January 18 – 21, 2000, Beijing, China

Source: Philips
To: WG2
Title: Draft LS on Timing Parameters

25.214 CR 052

Synchronisation procedure

Figure 1: Synchronisation establishment flow for dedicated channels: uplink dedicated channel not existing

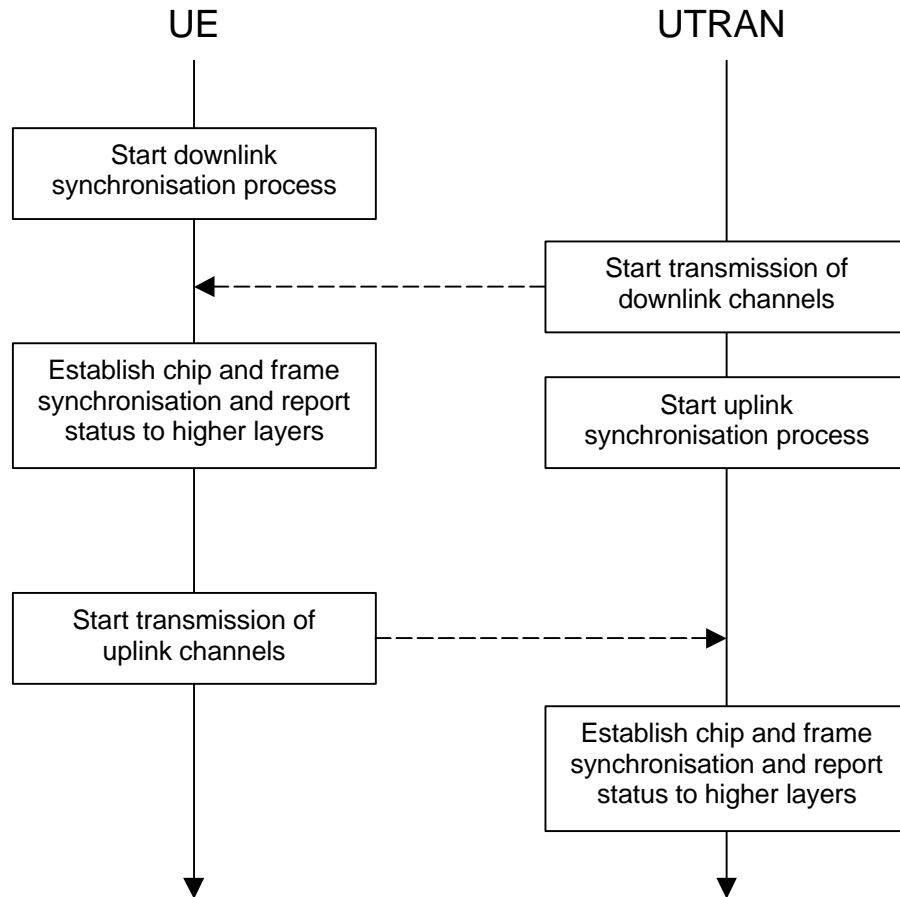
- a) UTRAN starts the transmission of downlink DPCCH/DPDCHs. The DPDCH is transmitted only when there is data to be transmitted to the UE.
- b) The UE establishes downlink chip synchronization and frame synchronization based on the CPICH timing and timing offset information notified from UTRAN. Frame synchronization can be confirmed using the Frame Synchronization Word. Successful frame synchronization ~~is~~ shall be confirmed and reported to the higher layers ~~when-if the first~~ S_{RU} successive frames ~~have been~~ are confirmed to be frame synchronized, ~~where~~ S_{RU} is a higher-layer parameter and $S_{RU} \cdot N_{offset,2}$ (see subclause 7.7 in [1]). Frame synchronisation shall also be reported to higher layers in any case if $S_{RU} = 0$. Otherwise, frame synchronization failure ~~is~~ shall be reported to the higher layers.

- d) UTRAN establishes uplink channel chip synchronization and frame synchronization. Frame synchronization can be confirmed using the Frame Synchronization Word. Successful frame synchronization ~~is~~ shall be confirmed and reported to the higher layers ~~when-if the first~~ S_{RN} successive frames ~~have been~~ are confirmed to be frame synchronized, ~~where~~ S_{RN} is a higher-layer parameter. Frame synchronisation shall also be reported to higher layers in any case if $S_{RN} = 0$. Otherwise, frame synchronization failure ~~is~~ shall be reported to the higher layers.

Figure 2: Synchronisation establishment flow for dedicated channels: uplink dedicated channel already existing

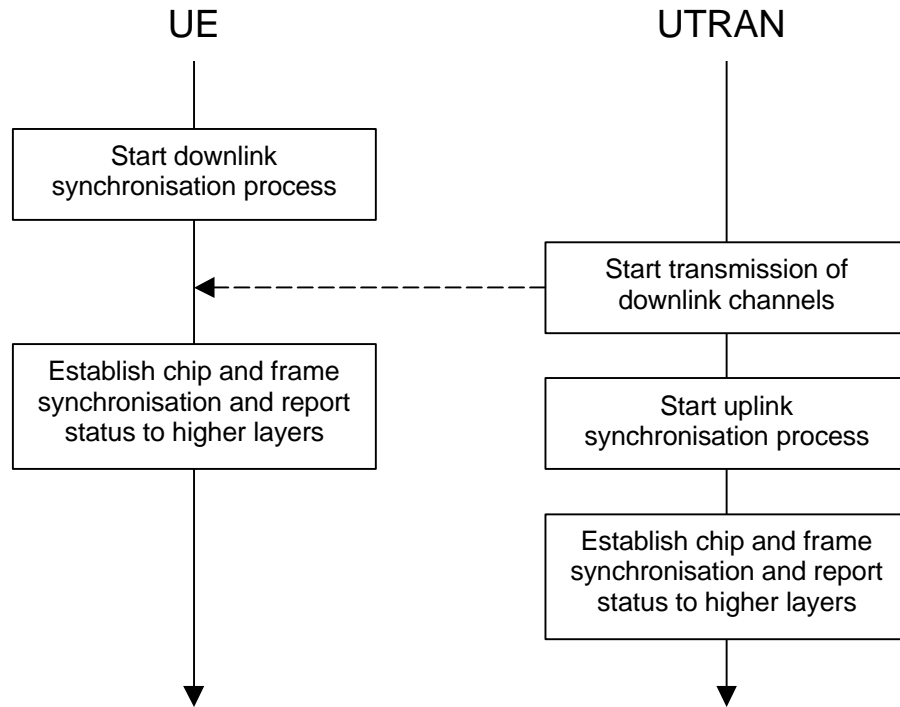
- UTRAN starts the transmission of the downlink DPCCH/DPDCH at a frame timing such that the frame timing received at the UE will be within $T_0 \pm 148$ chips prior to the frame timing of the uplink DPCCH/DPDCH at the UE. UTRAN then starts the synchronization establishment process of the uplink DPCCH/DPDCH transmitted by the UE. Frame synchronization can be confirmed using the Frame Synchronization Word. Successful frame synchronization ~~is shall be~~ confirmed and reported to the higher layers ~~when-if the first~~ S_{RN} successive frames ~~have been~~ confirmed to be frame synchronized, ~~where~~ S_{RN} is a higher-layer parameter. ~~Frame synchronisation shall also be reported to higher layers in any case if~~ $S_{RN} = 0$. Otherwise, frame synchronization failure ~~is shall be~~ reported to the higher layers.

- Based on the handover destination CPICH reception timing, the UE establishes chip synchronization of downlink channels from handover destination cell. Frame synchronization can be confirmed using the Frame Synchronization Word. Successful frame synchronization ~~is shall be~~ confirmed and reported to the higher layers ~~when-if the first~~ S_{RU} successive frames ~~have been~~ confirmed to be frame synchronized, ~~where~~ S_{RU} is a higher-layer parameter and S_{RU}

(see subclause 7.7 in [1]). Frame synchronisation shall also be reported to higher layers in any case if $S_{RU} = 0$. Otherwise, frame synchronization failure ~~is shall be~~ reported to the higher layers.
